MEMORANDUM
Town of Nags Head
Planning & Development Department

To: Planning Board
From: Kelly Wyatt, Planning Director
Joe Costello, Deputy Planning Director
Date: November 14, 2024
Subject: Site Plan Review, 105 W. Seachase Drive

Purpose/Request: Construction of an approximately 8,305 square foot Dare County Emergency Management Services (EMS) station and all associated site improvements. Note that "Future Additions" are not included as part of the Site Plan Review.

Date	Project No.
11/12/24	21032
Drawn By	Sheet No.
JH	A2.1
Checked By	
TDO	
Sheet Title	
EXTERIOR ELEVATIONS

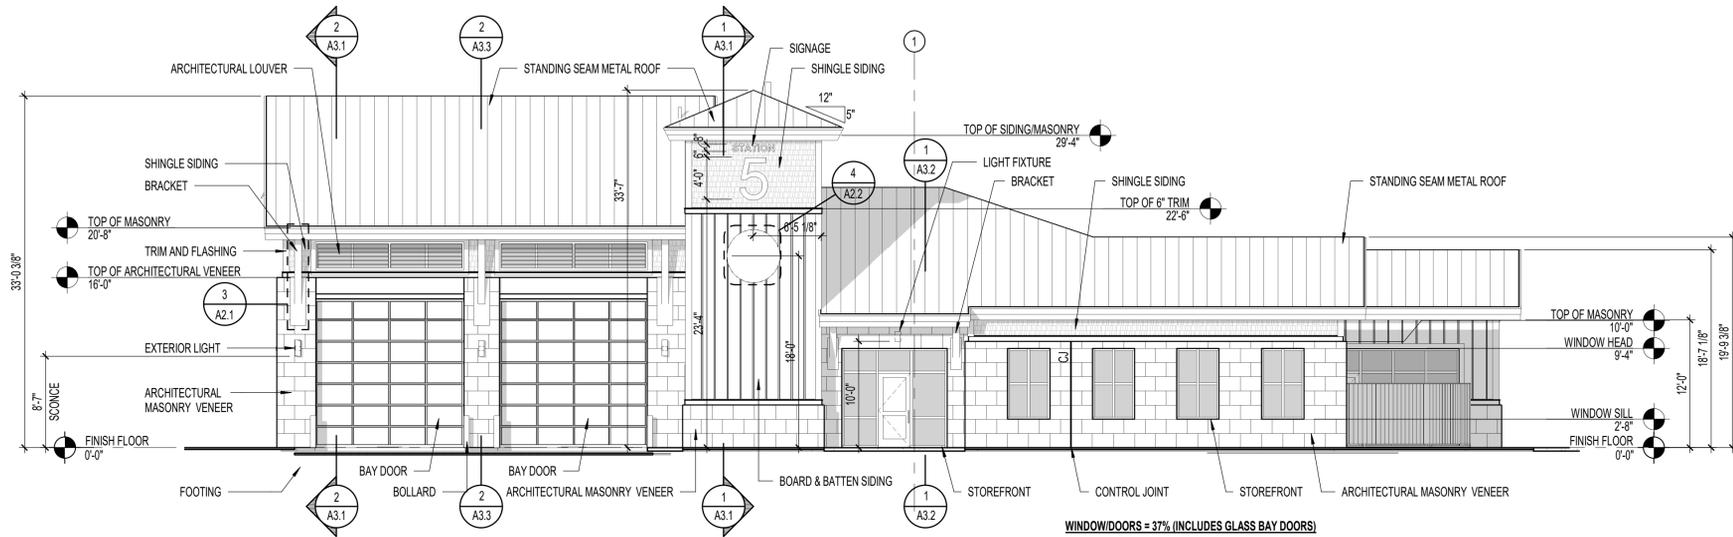
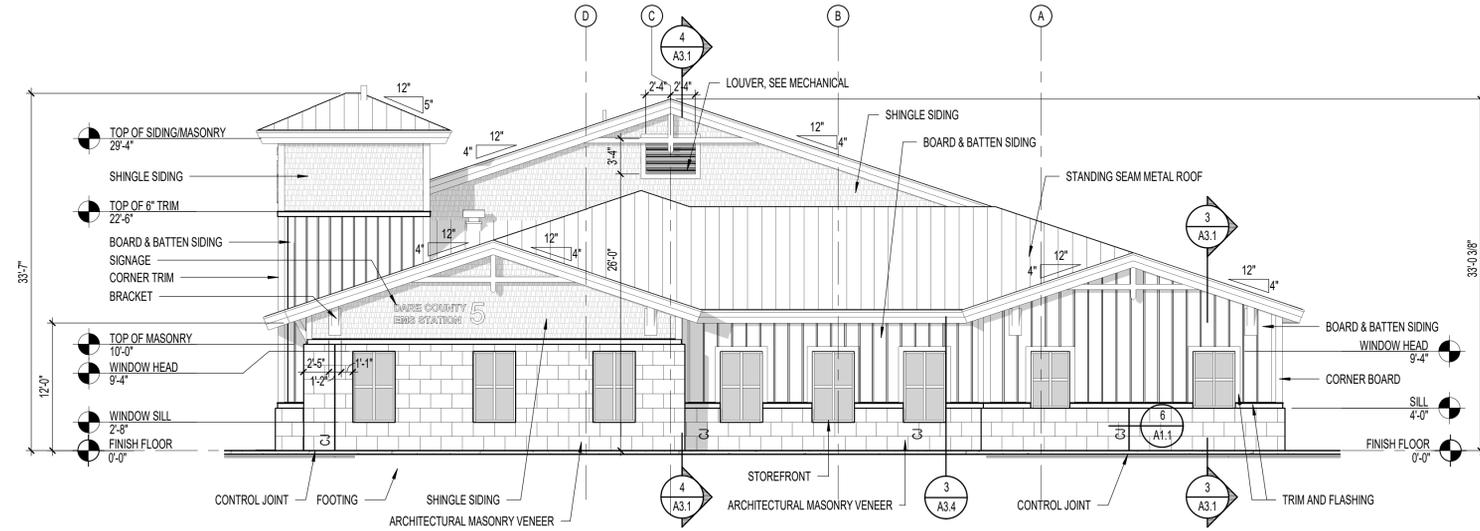
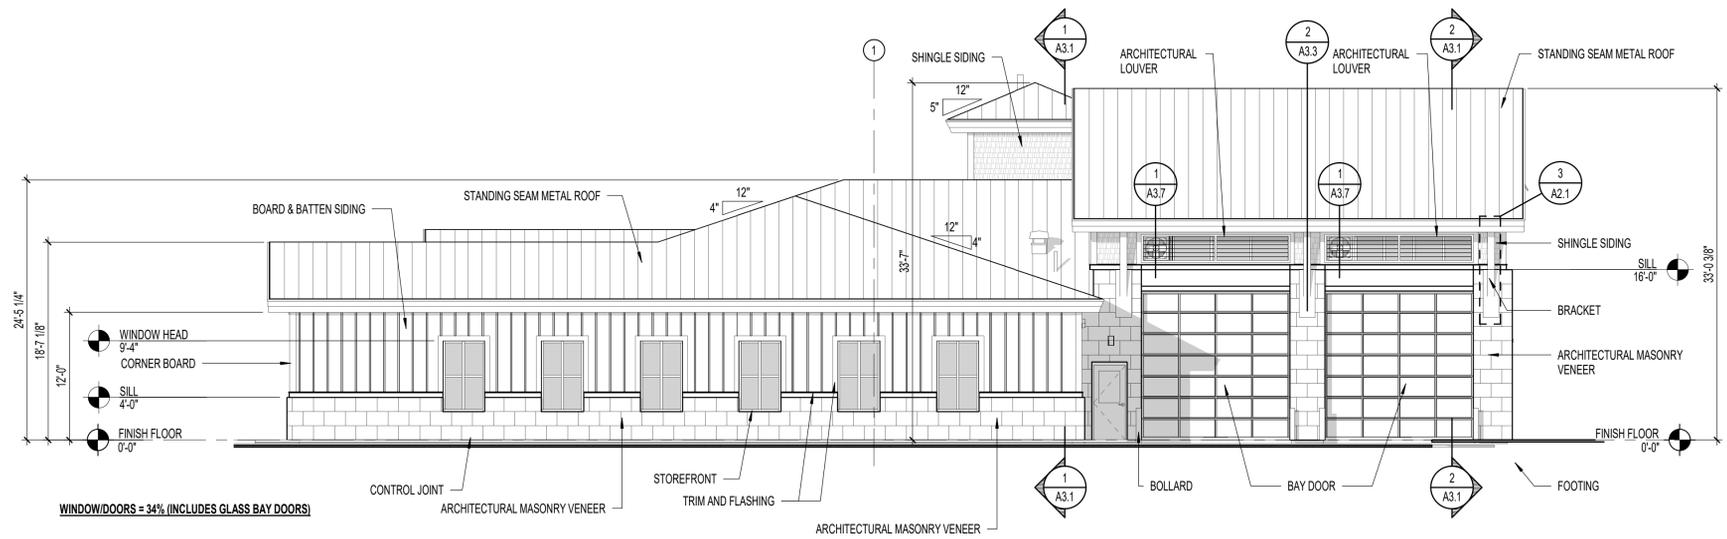
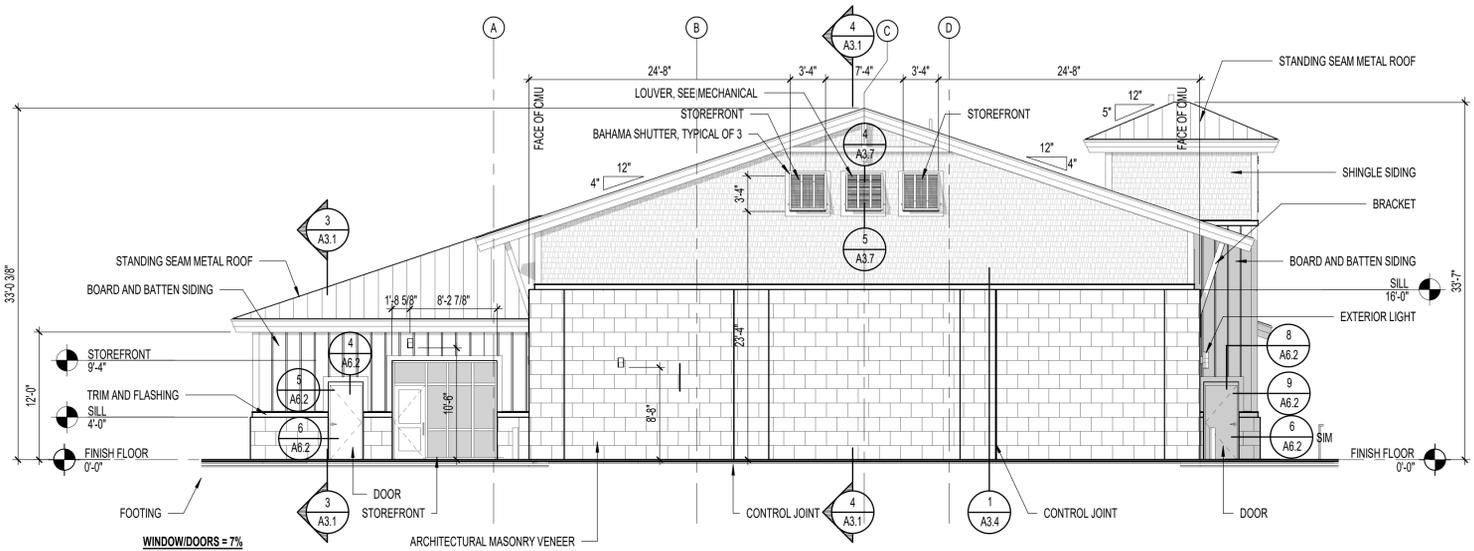
- Height: The maximum allowable building height within the Town is 35 feet; however, pursuant to Section 8.2.1, Dimensional requirements, total height may be increased to 42 feet with the use of an 8:12 roof pitch or greater. The applicant has proposed a structure with an overall height of approximately 34 feet measured from grade, therefore height is compliant. A height certificate will be required to verify overall height compliance during construction.

- Architecture Design Standards: Section 10.82 of the UDO, Applicability, states that Commercial Design Standards shall apply to all building construction or remodeling projects requiring a special use permit or site plan review. This project must adhere to the Commercial Design Standards set forth within Part VI of the UDO. As proposed this project will comply with standards set forth in Division II – Building Design including a human scale design, various roof articulations including a watch tower, residential style window, exterior masonry with board and batten and shingle siding, workable shutters, and gable brackets.

This structure is located within the Village at Nags Head and as such should be reviewed and approved by their Architectural Control Committee (ACC). The applicant has provided the Village ACC with the architectural renderings and is awaiting their review comments.
